Re: Response to Request for Further Information – Section 92 RMA

Application: BUN60453420 (LUC60453421 and DIS60453422)

We write in response to Council's Section 92 Request for Further Information (dated 13 August 2025) for the above application. The following responses address items 2, 5, 6, 7, 8, 11, and 16–20 of the request.

DWG EARTHWORKS PLAN

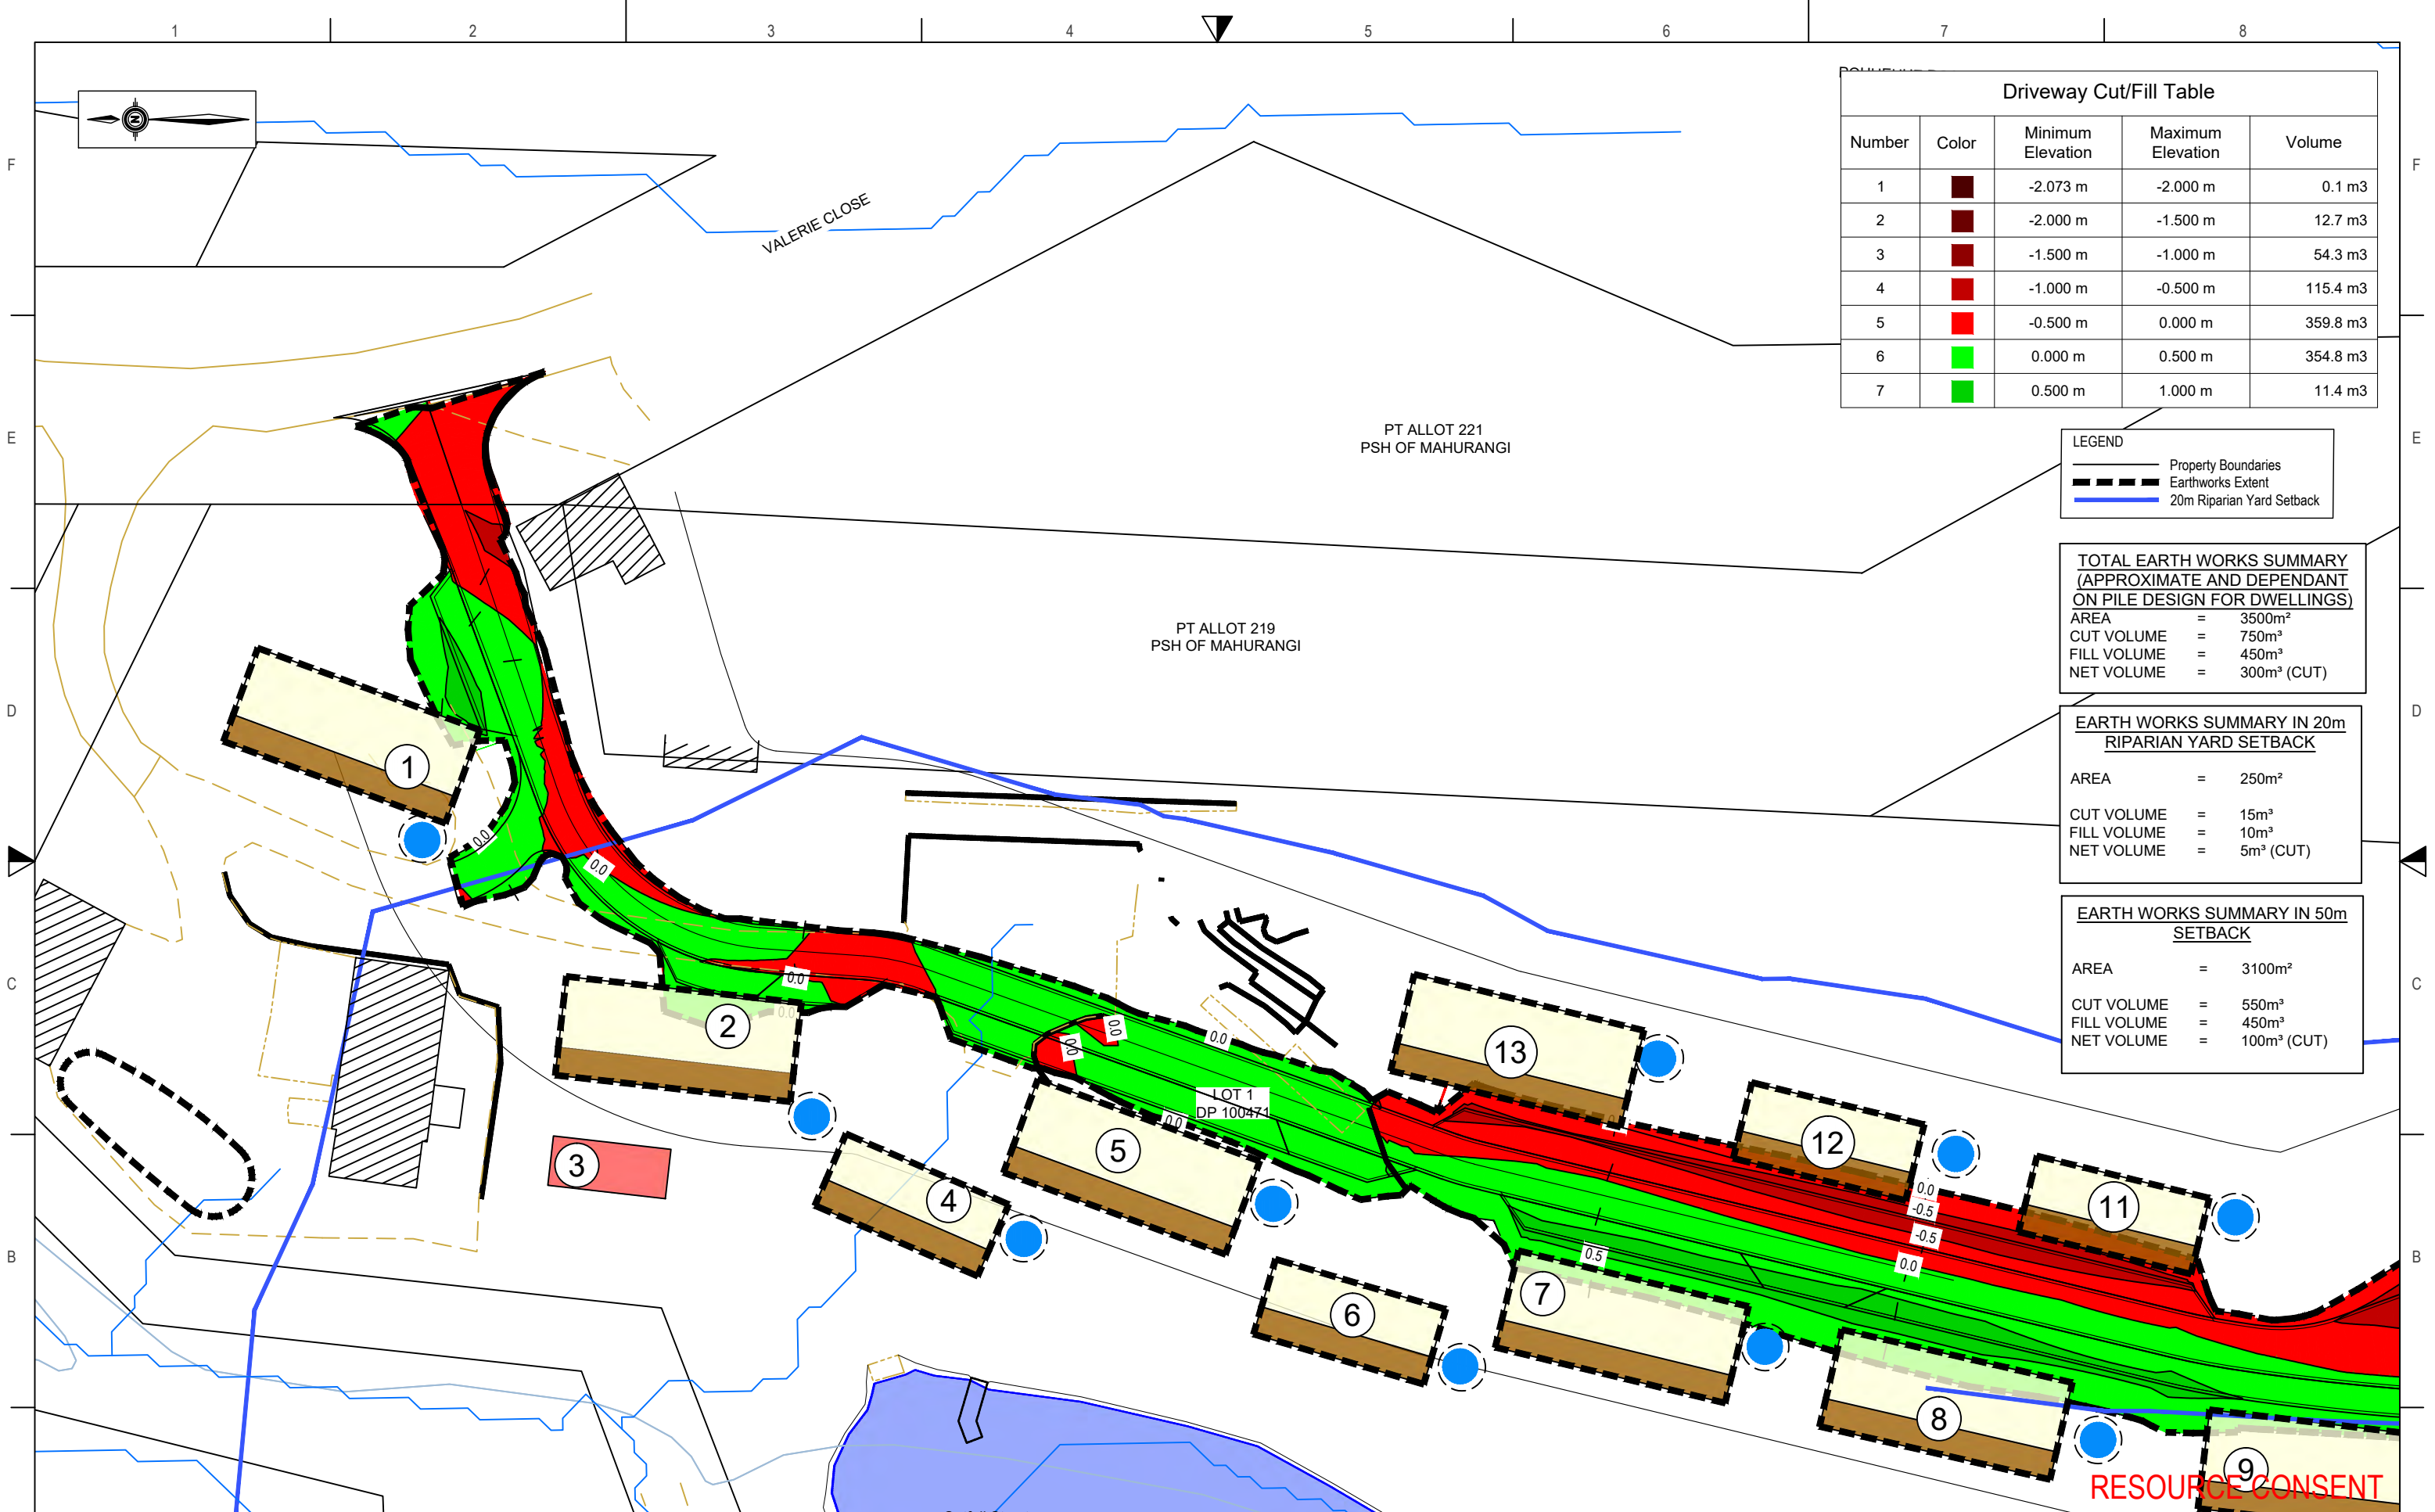
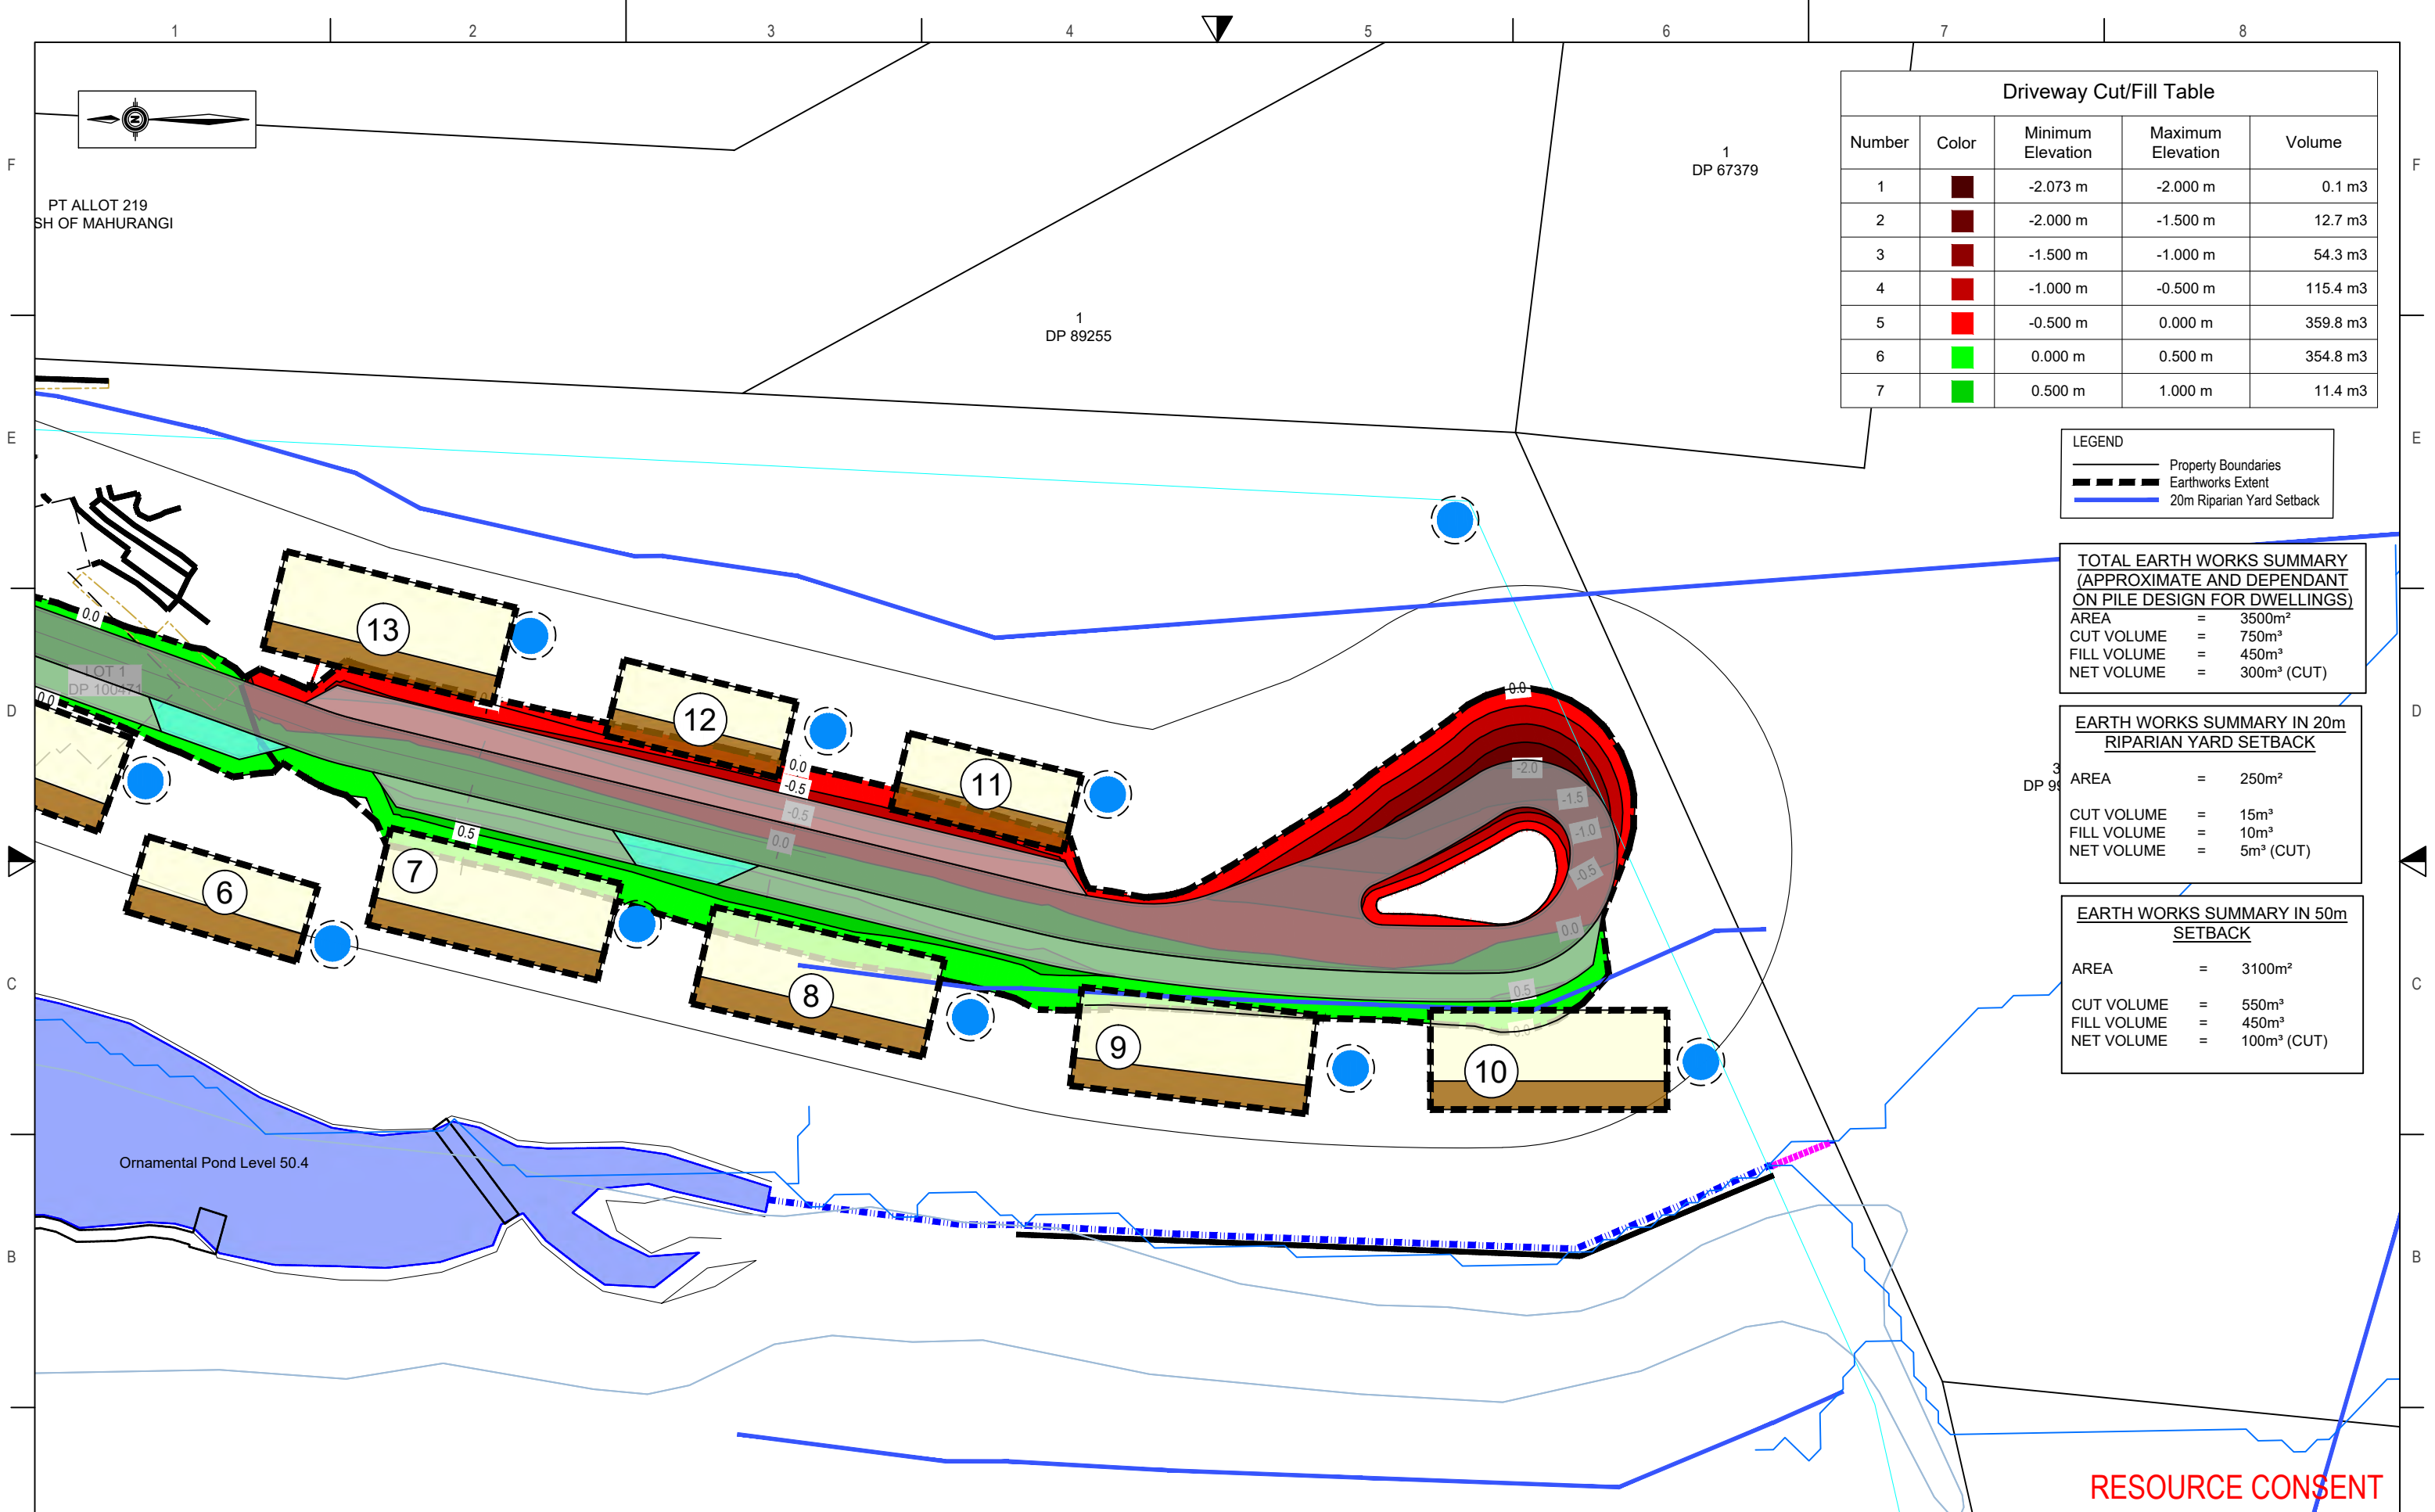
Q5. Please clarify whether the wastewater treatment system tanks will require earthworks for installation. If yes, please update "Earthworks Plan" Drawing No. GEO-04 to include their location.

Q6. Please clarify whether the water tanks to be installed will require earthworks. If yes, please update "Earthworks Plan" Drawing No. GEO-04 to include their location.

Q8. Please clarify whether the construction of the timber piles will meet the definition of earthworks under Chapter J of the AUP(OP). If so, please amend “Earthworks Plan” Drawing No. GEO-04 and Drawing No. GEO-05 to include their location and amend the total earthworks quantities to include them.

Yes, the installation of the wastewater treatment tanks will require localised excavation. The required volumes have been calculated and added to the overall earthworks quantities. Their locations are shown on the updated Earthworks Plan GEO-04-05 Rev C.

Yes, water storage tanks will require minor excavations for foundations and placement. As the tanks are proposed to be above ground only minor earthworks is required. These locations and approximate associated volumes have been added to the revised Earthworks Plan GEO-04-05 Rev C.

The timber piles will be installed using localised drilling and are expected to slightly exceed 250mm diameter and therefore meet the AUP(OP) definition of earthworks. The minor additional excavation volumes are now included in the total earthworks quantities on drawing Earthworks Plan GEO-04-05 Rev C.
